U.S. Department  
of Transportation  
**Federal Highway  
Administration**

In Reply Refer To:  
HSSI/B-205

Name of system:	CRMcrete Weed Barrier
Type of system:	W-Beam Guardrail with rubberized concrete weed barrier
Test Level:	NCHRP Report 350 TL-3
Testing conducted by:	CALTRANS
Date of request:	February 25, 2010
Date initially acknowledged:	April 1, 2010
Date of completed package:	October 19, 2010

Figure #-## CRMcrite Weed Barrier Plan and Cross Section

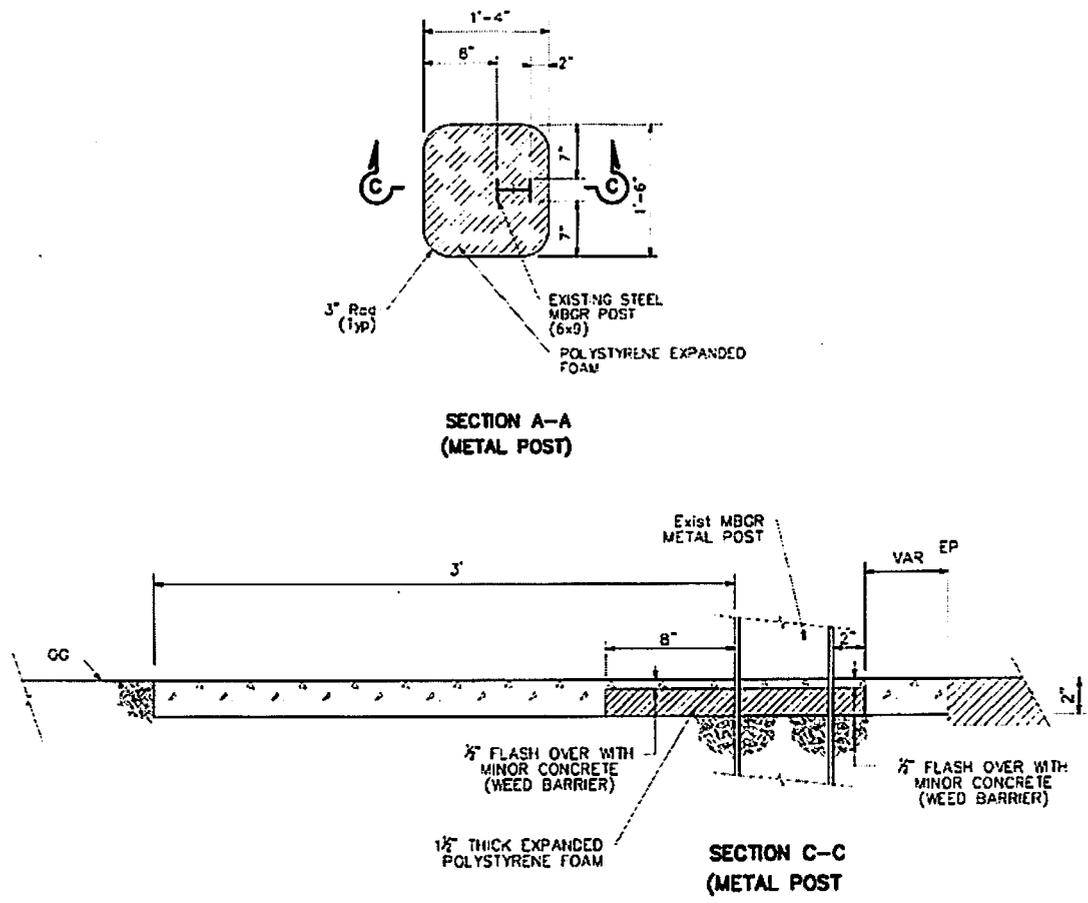
The CRMcrete weed barrier was composed of a 6-sack concrete mix with 5 lb per cubic yard of concrete reinforcing fibers and 3 percent by weight crumb rubber material. The weed barrier was 4 feet, 8 inches wide by 2 inches thick and the leave-out holes were 16 x 16 inches, but the post was not centered in the hole (see enclosed file Test 659 Test Article). The 28-day compressive strength was 1863 psi. The percentage of crumb rubber in the mix may be varied as long as the 28-day compressive strength is less than 1863 psi. The width of the weed barrier may be adjusted to suit conditions without affecting performance.

The weed barrier was tested under a "Modified G4(1S)" guardrail installed in native soil. The design height was 27-3/4 inches with a tolerance of plus or minus one-half inch. The actual height (measured at posts) downstream of the impact point ranged from 27-3/4 inches to 28-1/4 inches. A drawing of the California Department of Transportation standard guardrail is enclosed for reference.
